UN Regulation No. 79

ACSF C

Amendment for HMI

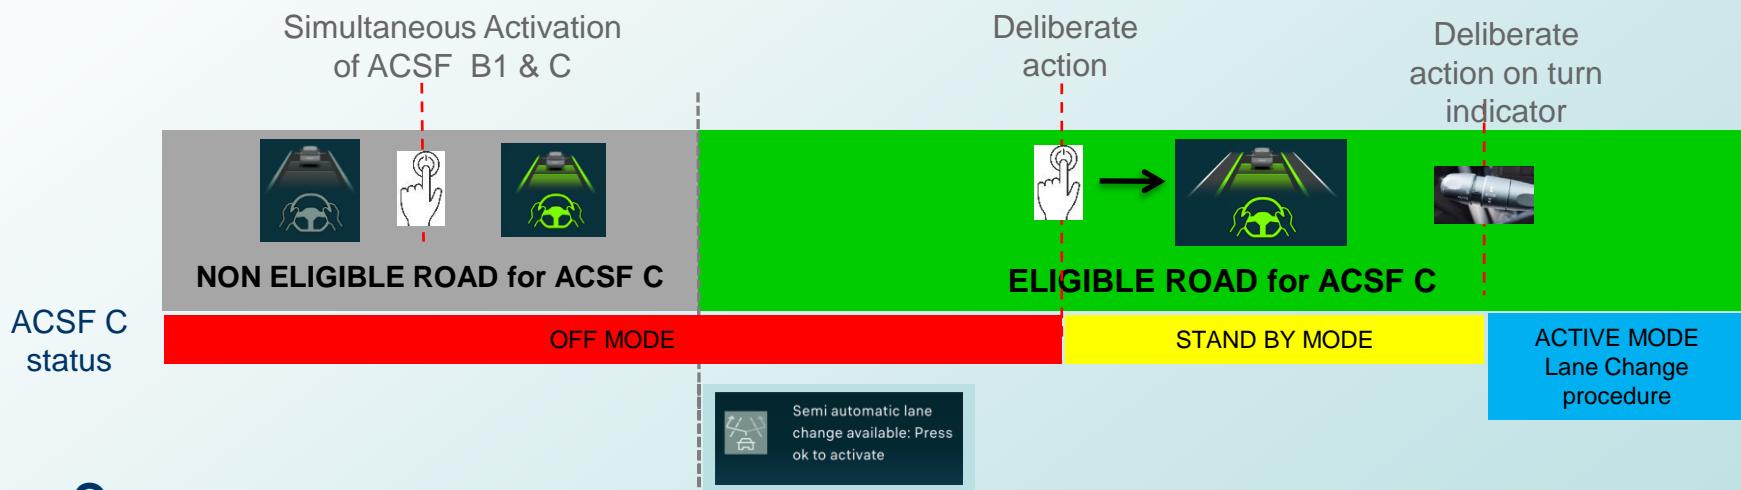
Use case 2 : When B1+C is activated on a none ACSF C eligible road – a second deliberate action to activate the ACSF C is needed when the vehicle enters the ACSF C eligible road

Consequences:

- Risk of confusing the driver with this logic of actions (frequently reported by numerous customers).
- The procedure is more complex for the driver.
- That will discourage him from using this function.

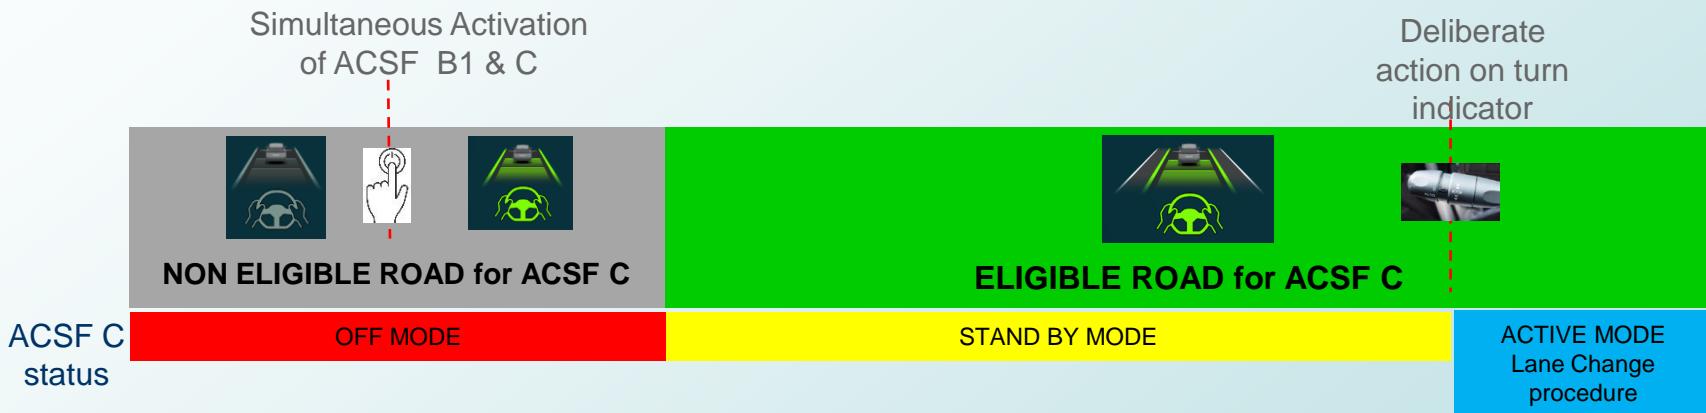
- We propose that, in a situation such as use case 2:

A deliberate action to activate ACSF C on a non-eligible road, could consider ACSF C has being in a Standby mode when entering such an eligible road.

Amend to read § 5.6.4.2.3

§ 5.6.4.2.3. The system shall only be activated (standby mode) after a deliberate action by the driver. Activation by the driver shall only be possible on roads where pedestrians and cyclists are prohibited and which, by design, are equipped with a physical separation that divides the traffic moving in opposite directions and which have at least two lanes in the direction the vehicles are driving. These conditions shall be ensured by the use of at least two independent means.

Notwithstanding the activation criteria above and following the activation request at any type of road by a deliberate action with the same means as for ACSF of category B1, the ACSF of category C may turn automatically to standby mode when entering a type of road as described above.

In the case of a transition from a road type with a classification permitting an ACSF of Category C, to a type of road where an ACSF of Category C is not permitted, the system shall be deactivated automatically (off mode), unless a missing second lane in driving direction is the only condition not fulfilled from the above (e.g. a connector between two highways).
